Caesar Apparels Ltd New (Extension)

Yakub Synthetic Building, PBA Road, Moijjartek, Shikalbaha, Upzilla: Patiya, Chattogram
(22.316036, 91.855888)

9 December 2024

Observation 02: Discrepancies in the as-built drawings (Production Shed).

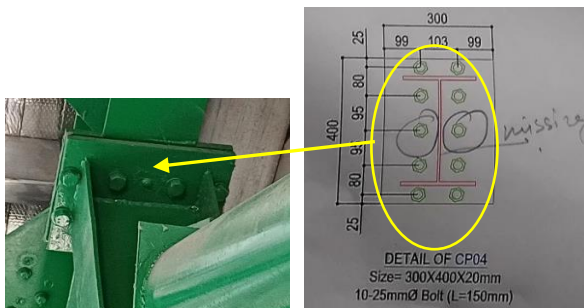
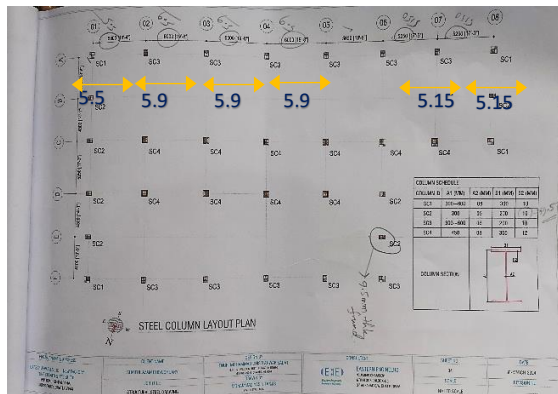
Description: Discrepancies were found in the CP-04 connection at 1B, 1C, 1D, 1E, 6C, 6D and 6E (no. of bolts found 8 instead of 10 bolts). Also, grid distances were found 100 mm less in all grids except the 05-06 grid along the East-West direction. Furthermore, no structural details (roof members, connection details etc.) were provided in the structural drawing for the adjacent toilet block. The building engineer is required to survey the whole structure and prepare accurate as-built drawings as per actual site condition.

2.		Carry out suggested remedial works if required.	within 6 months
3.	Discrepancies in the as-built drawings (Production Shed).	The building engineer is required to survey the whole structure and prepare accurate as-built drawings as per actual site conditions.	within 6 weeks

Observation 03: Connection gap (Production Shed)

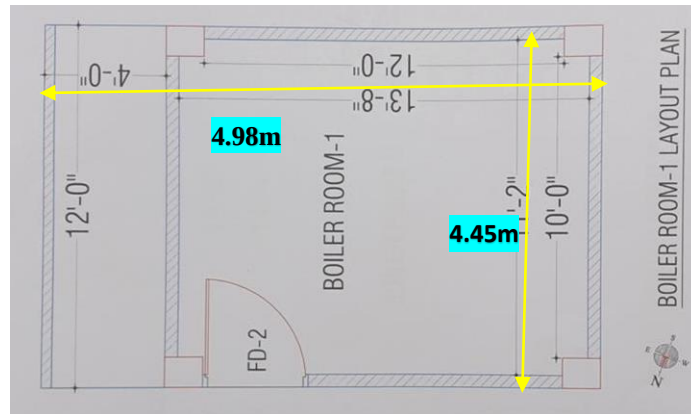
Description: During inspection, connection gaps were found in beam-column connections. The building engineer is required to repair the connection gap with a suitable method.

4.	Connection gap (Production Shed)	The building engineer is required to repair the connection gap with a suitable method.	within 6 weeks
5.	Discrepancies in as-built drawings (Boiler Room-02)	The building engineer is required to survey the whole structure and prepare accurate as-built drawings as per actual site conditions.	within 6 weeks

Observation 05: Hairline cracks on roof slab and beams (Boiler Room-02)

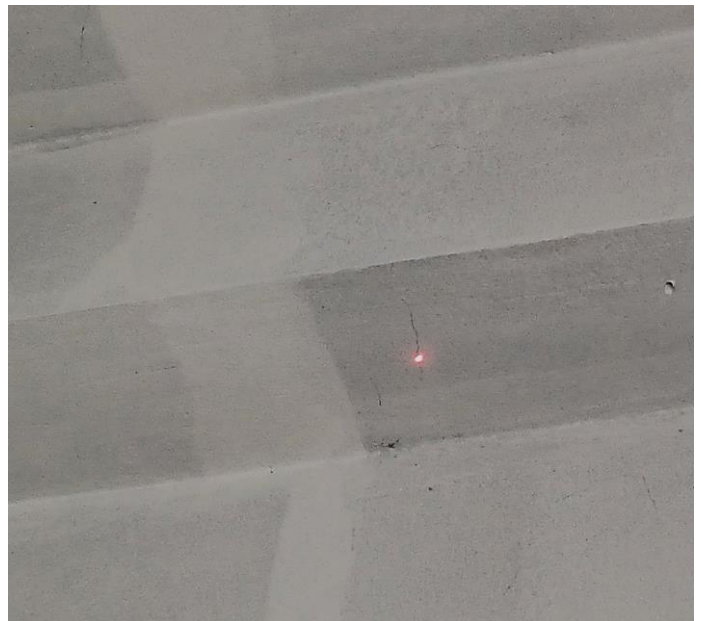
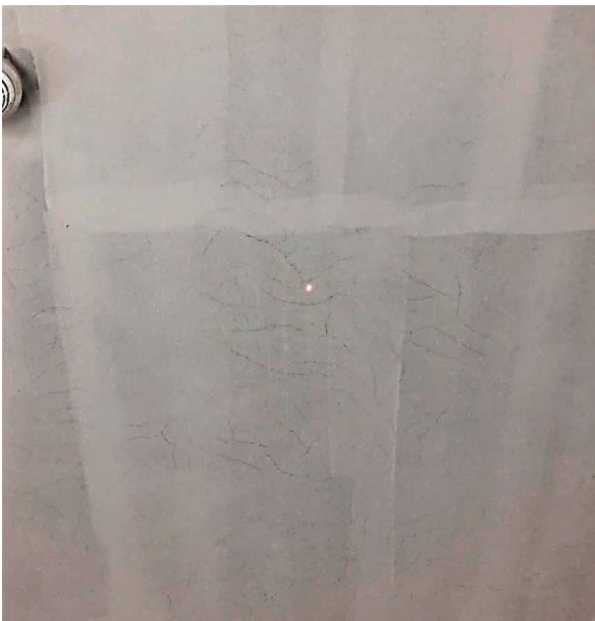
Description: During the inspection, hairline cracks were found on the roof slab and beams. The building engineer is required to investigate the reason and repair the cracks accordingly.

6.	Hairline cracks on roof slab and beams (Boiler Room-02)	The building engineer is required to investigate the reason and repair the cracks accordingly.	within 6 weeks
